U.S. Department
of Transportation

March 30, 2000

Refer to: HSA-CC64

In your February 28 letter, you requested the Federal Highway Administration's (FHWA) acceptance of your U-MAD 100K truck mounted attenuator (TMA) at the National Cooperative Highway Research Program (NCHRP) Report 350 test level 3 (TL-3). To support your request, you included copies of three test reports prepared by the Transportation Research Center in East Liberty, Ohio, and videotapes of the tests that were conducted. After reviewing the material, Mr. Richard Powers of my staff requested additional drawings of your TMA. These were delivered to him on March 21.

ENCLOSURE 1 (1 OF 2)

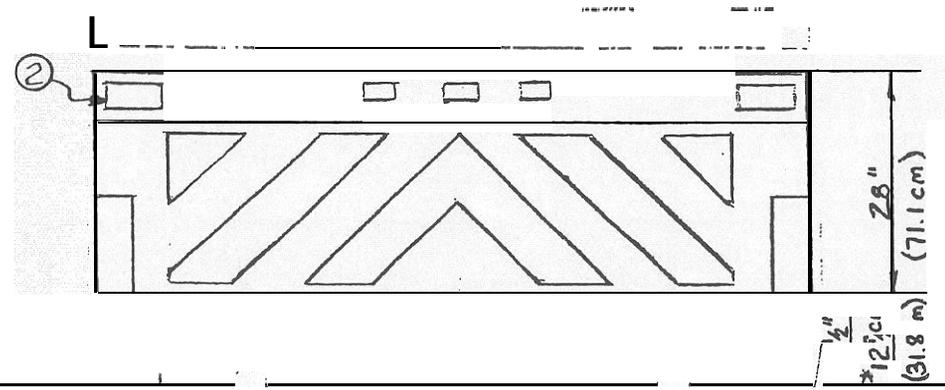
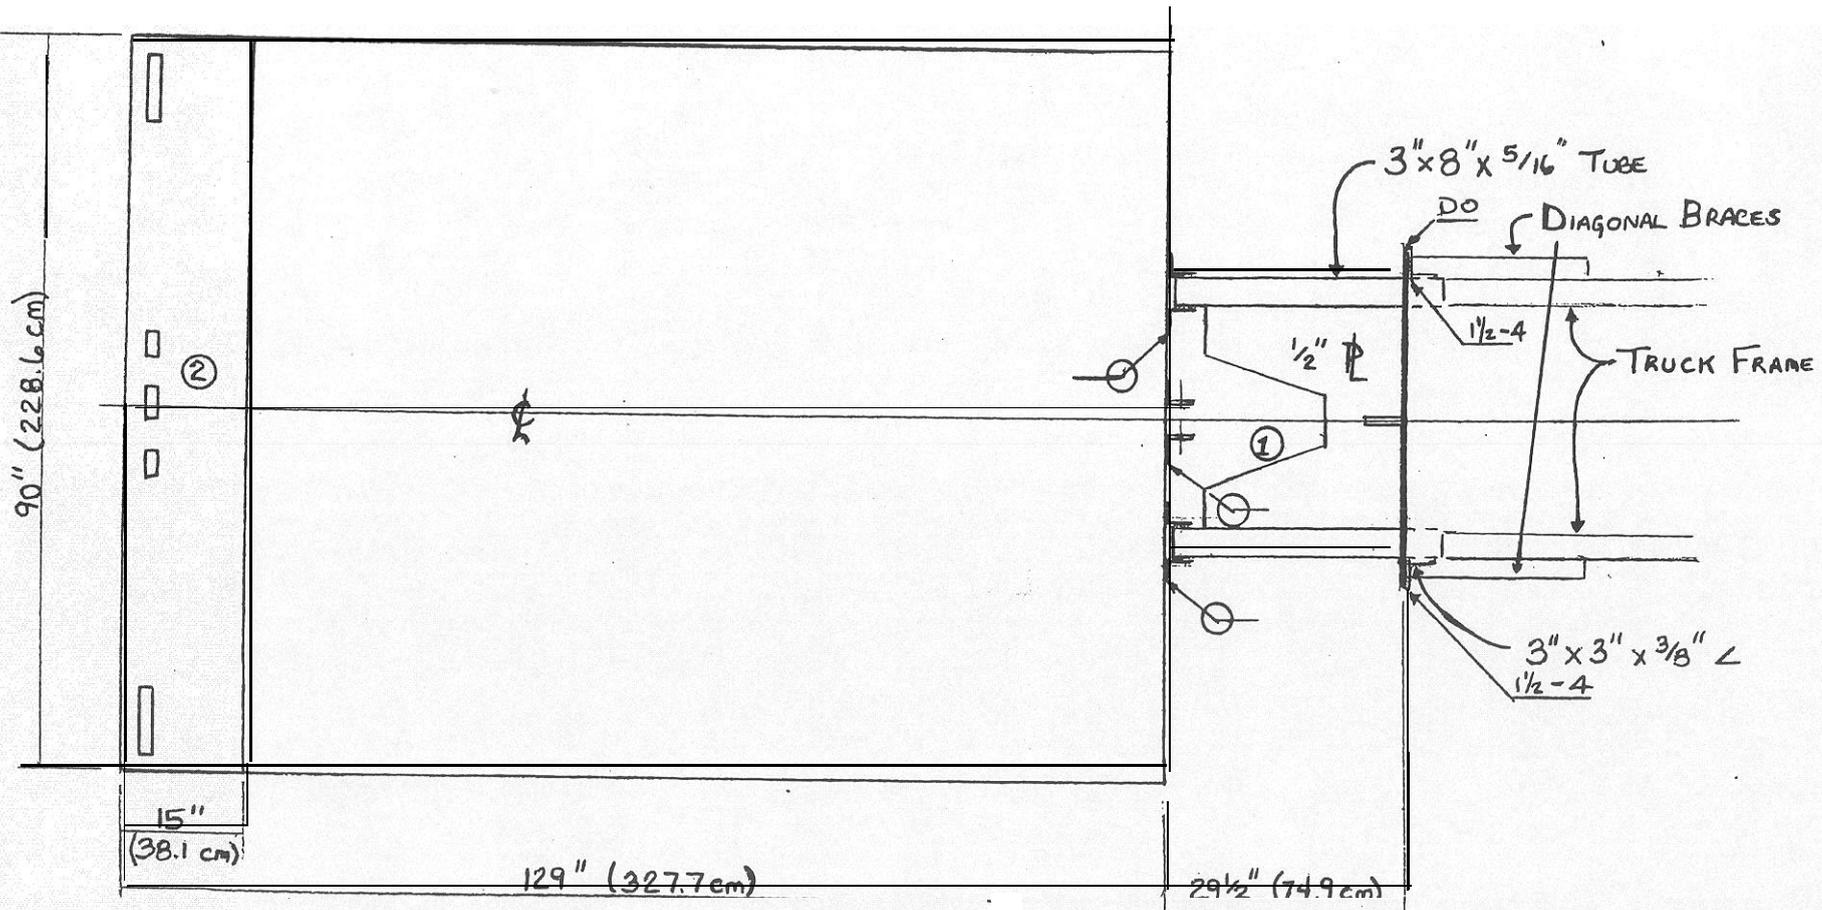
The U-MAD 100K TMA consists of an aluminum box containing eight separate internal compartments filled with variable density energy-dissipating material. The unit is 3277-mm (129 inches) long, 2286-mm (90 inches) wide and weighs approximately 413 kg (910 pounds), excluding the weight of the mounting bracket and lift mechanism which is 157 kg (346 pounds). A schematic drawing of the U-MAD 100K is shown as Enclosure 1.

Since the impact speed in test 3-50 was slightly higher than the nominal 100 km/h, we are willing to accept the occupant impact velocity of 12.3 m/s which is 0.1 m/s higher than we have previously considered to be the limit for acceptance. However, for both this test and test 3-51, the evaluation criteria for occupant impact velocity and ridedown accelerations are at the upper limits recommended by NCHRP Report 350. If impact speeds had been any higher or if the

support vehicle had a test inertial mass heavier than 8613 kg, the U-MAD 100K would not likely have been acceptable at TL-3. Thus, it may be considered acceptable for use on the National Highway System (NHS) at TL-3 provided its support vehicle is no heavier than the 8613-kg truck used for the test. If you wish to mount it on a heavier support vehicle, it must be tested with that vehicle. If mounted on a lighter vehicle, the expected roll ahead distances will be longer and the level of risk to the driver of the support vehicle will be increased. Therefore, it should not be used on a shadow truck significantly lighter than 8613 kg without additional testing.
